SOUTHERN CALIFORNIA EDISON  
TRANSMISSION AND DISTRIBUTION

Distribution Overhead  
Construction Standards  
(DOH)

**2019 — SECOND QUARTER ISSUE**

## Revision Summary

**Figure AP 338-1: Horizontal Inverted Alduti-Rupter Switch**

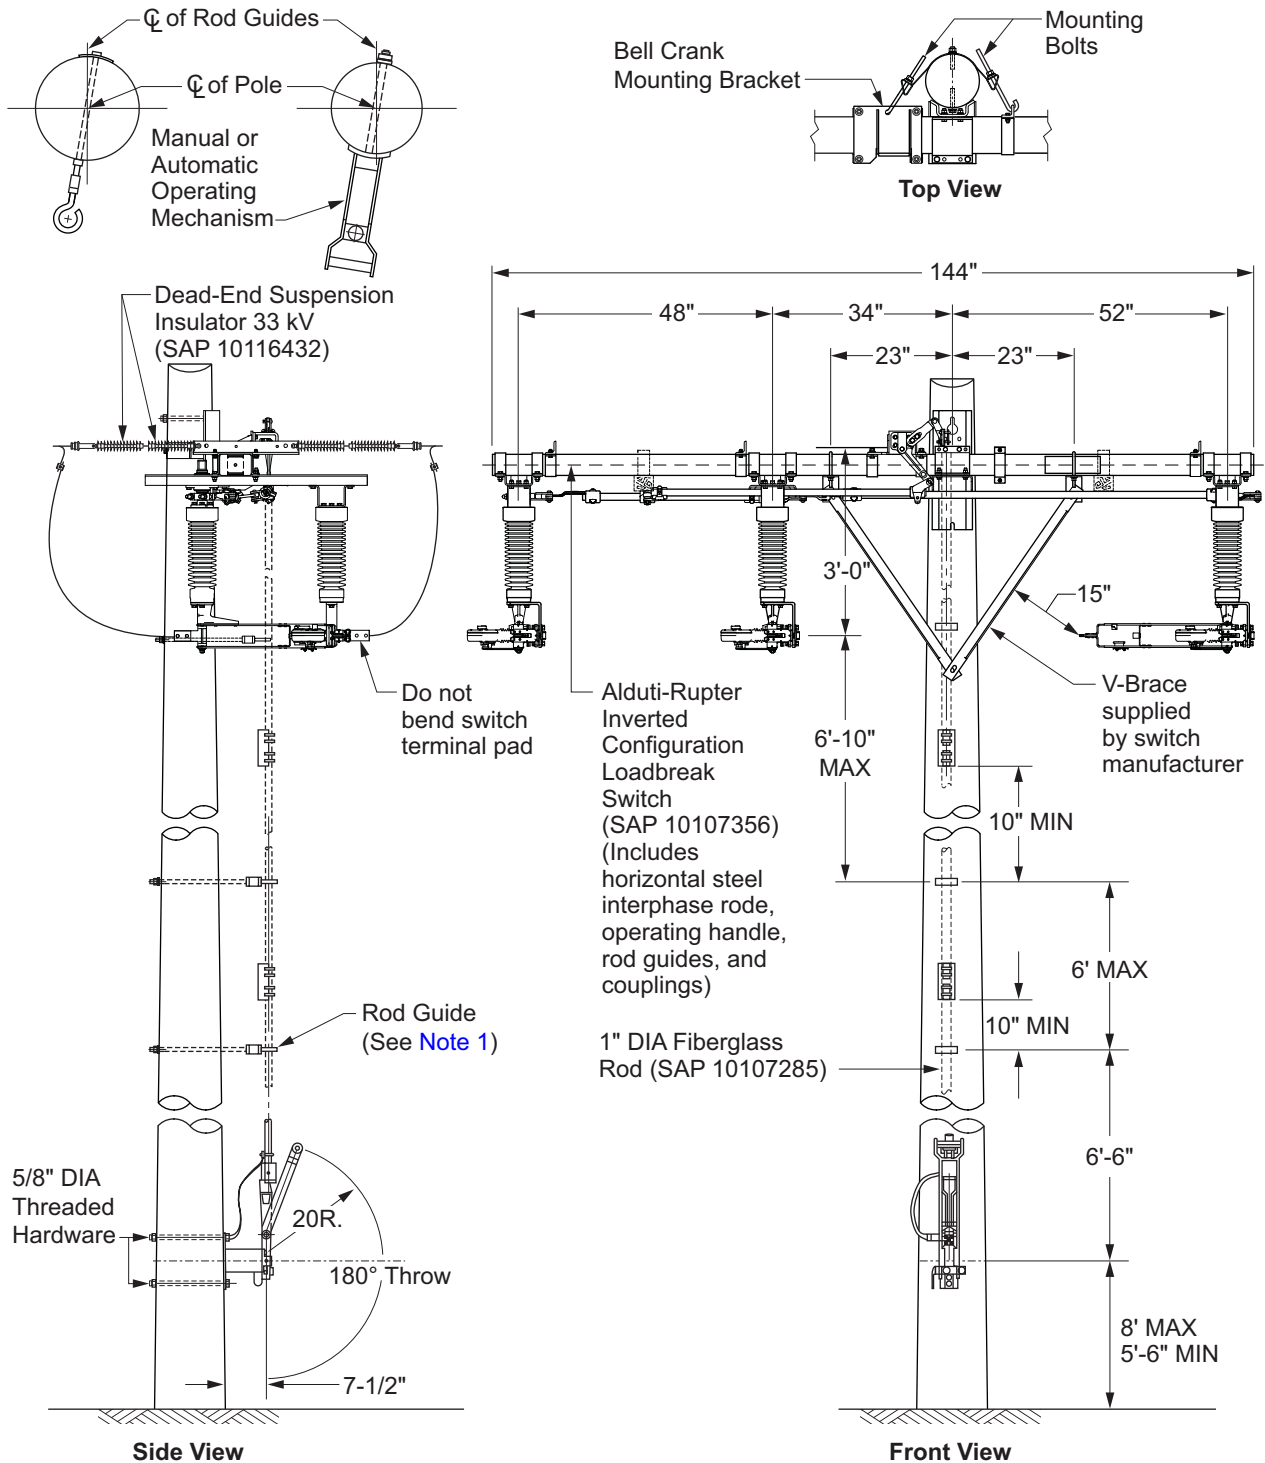
**What's Changed?** Updated Figure AP 338-1 to show increased number of insulators for easier formation of jumper wires.

**Figure AP 338-2: Horizontal Configuration Inverted-Type, 600 A, 38 kV Alduti-Rupter Load-Break Switch, for 33 kV Riser Applications**

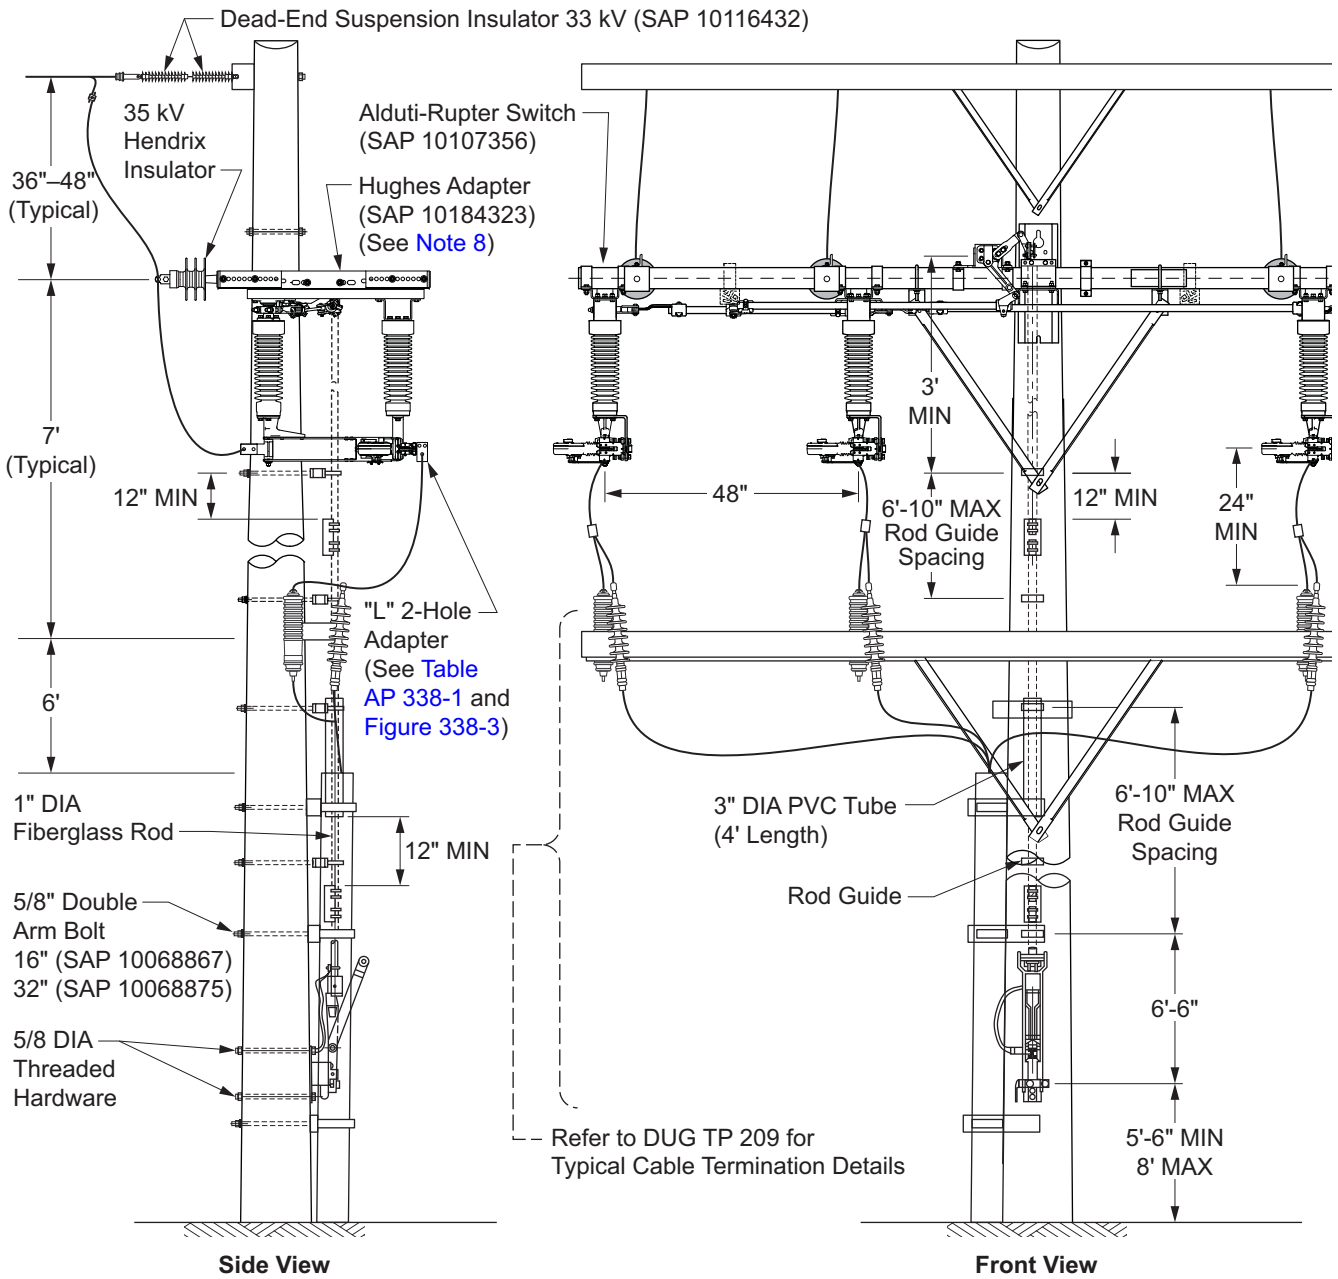
**What's Changed?** Updated Figure AP 338-2 to show increased number of insulators for easier formation of jumper wires.

Figure AP 338-4: Vertical Alduti-Rupter Switch

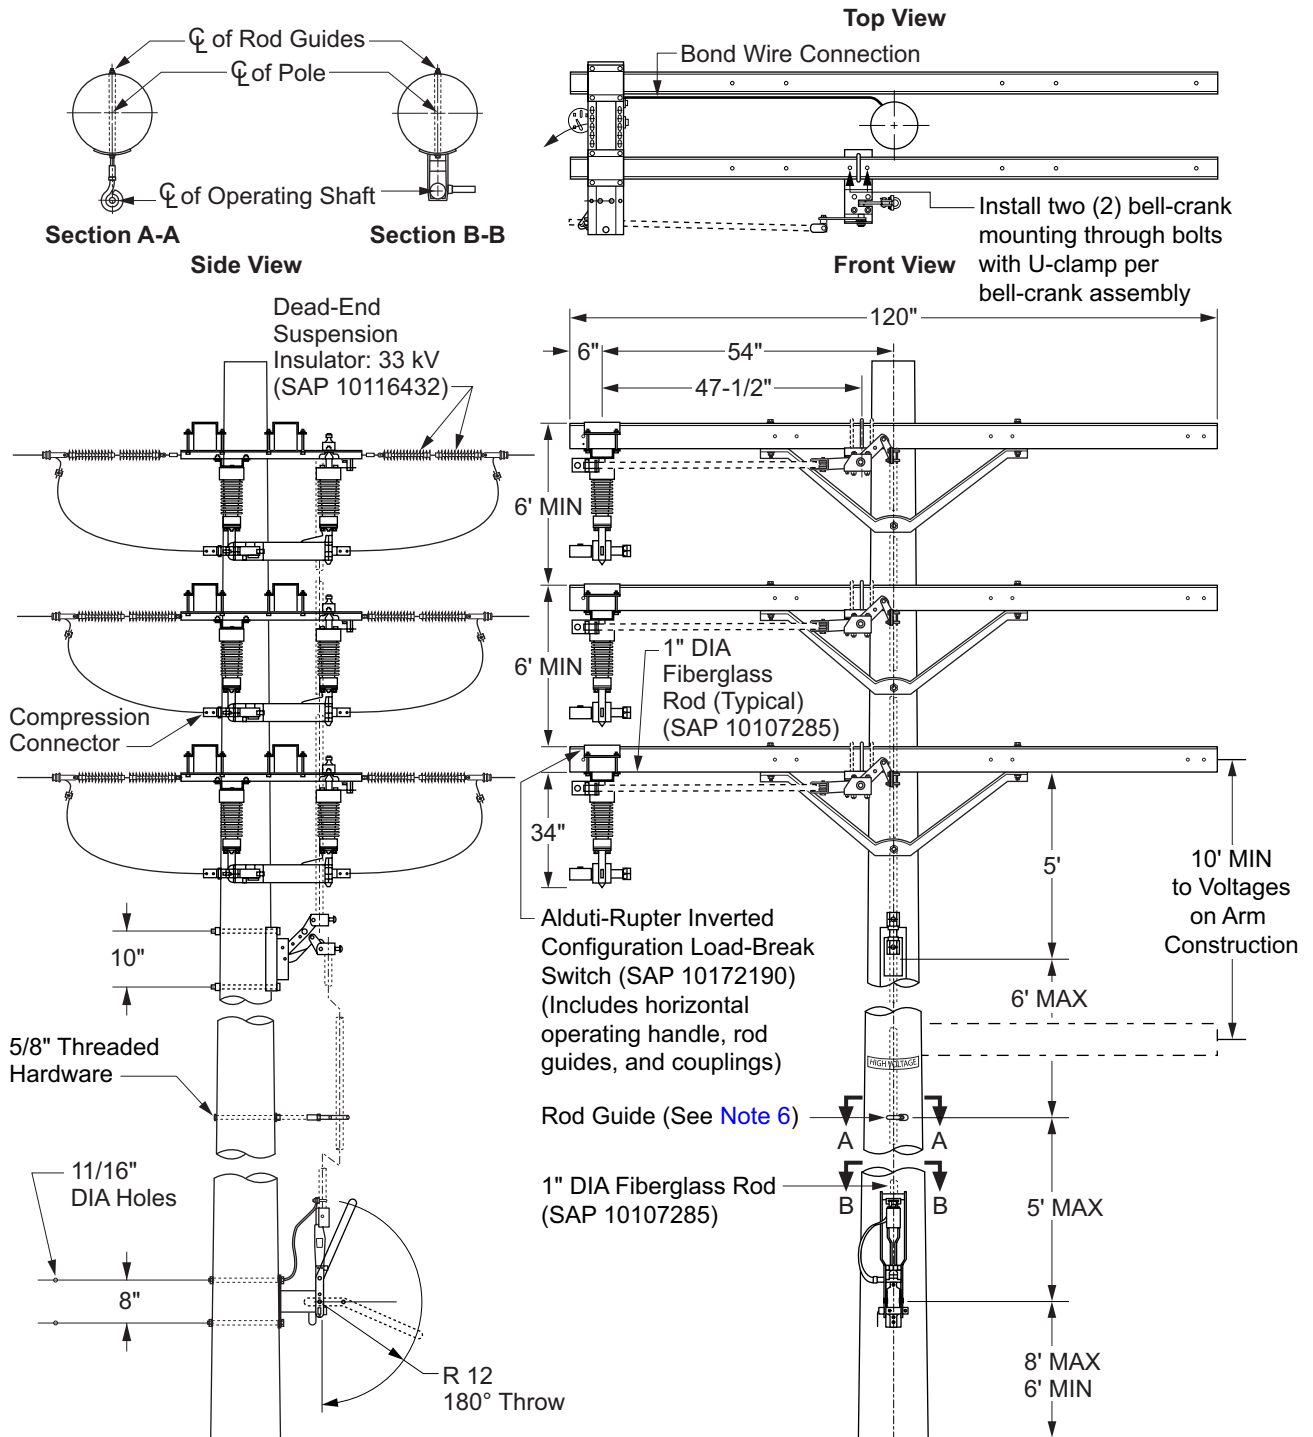
**What's Changed?** Updated Figure AP 338-4 to show increased number of insulators for easier formation of jumper wires.

Figure AP 339-1: Automated Horizontal Inverted Alduti-Rupter Switch

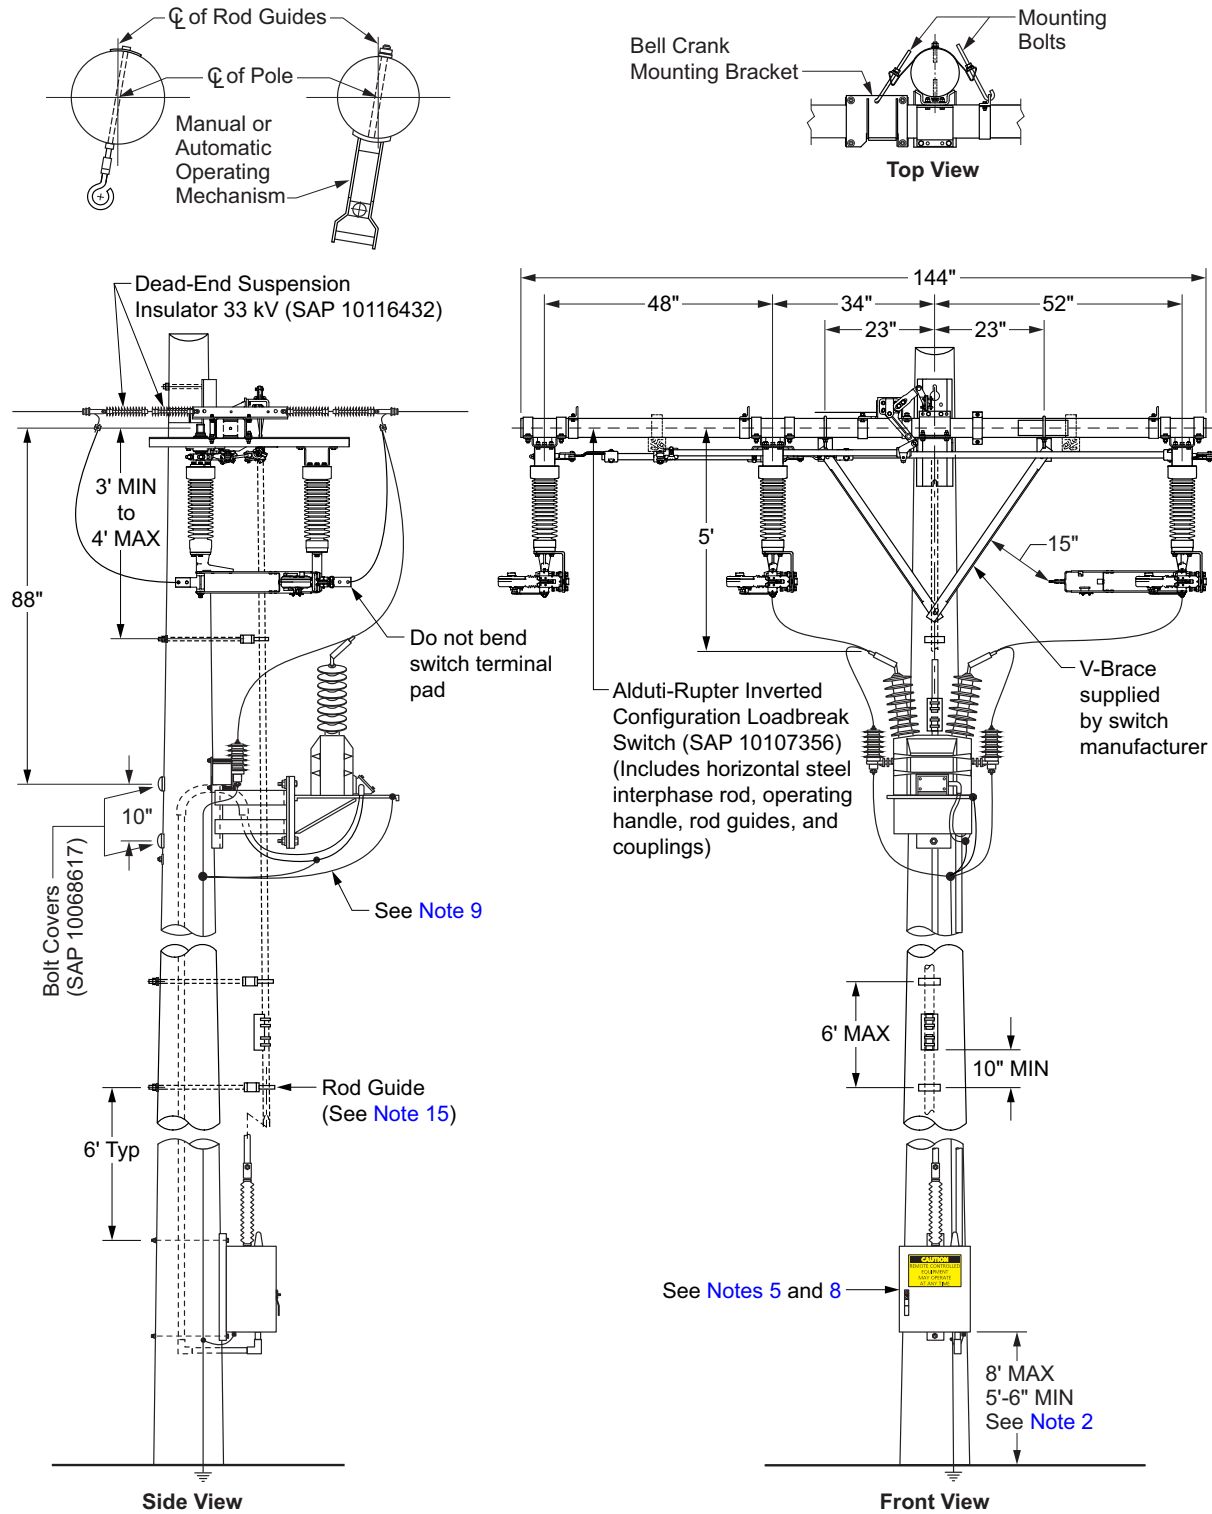
**What's Changed?** Updated Figure AP 339-1 to show increased number of insulators for easier formation of jumper wires.

Figure AP 339-2: Automated Vertical Inverted Alduti-Rupter Switch

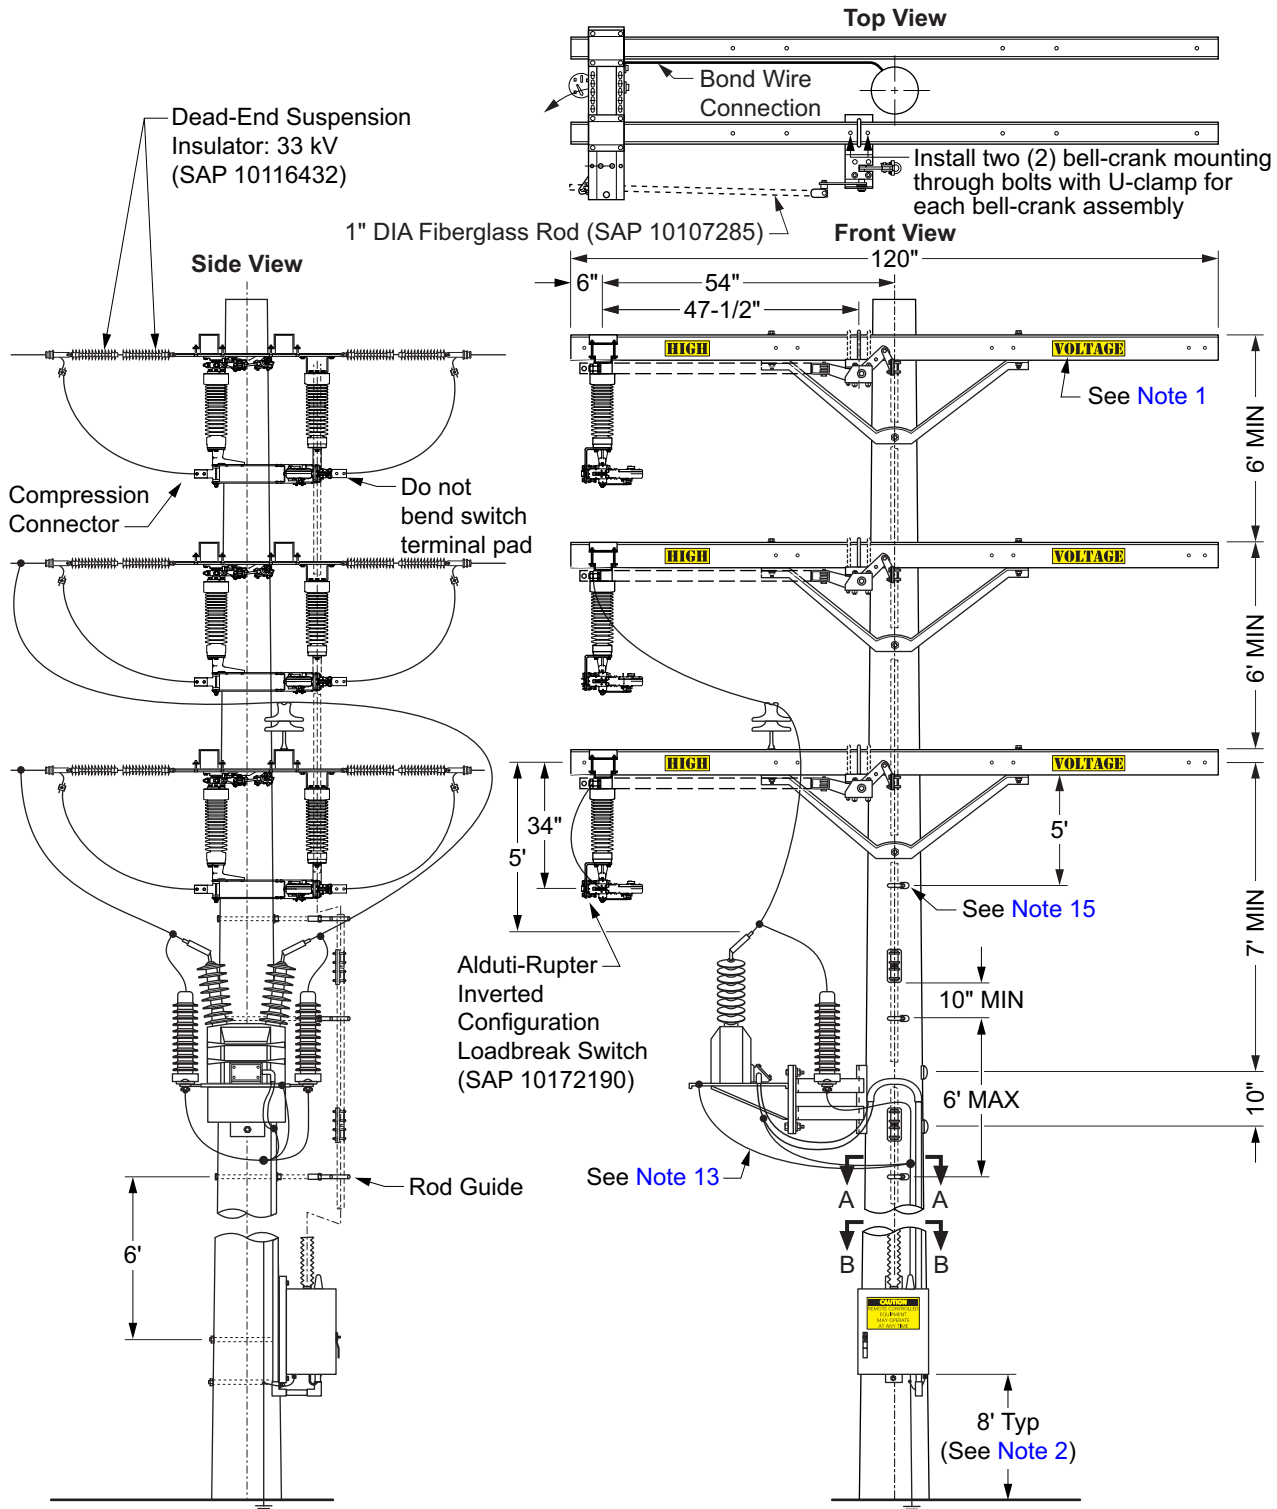
What's Changed? Updated Figure AP 339-2 to show increased number of insulators for easier formation of jumper wires.
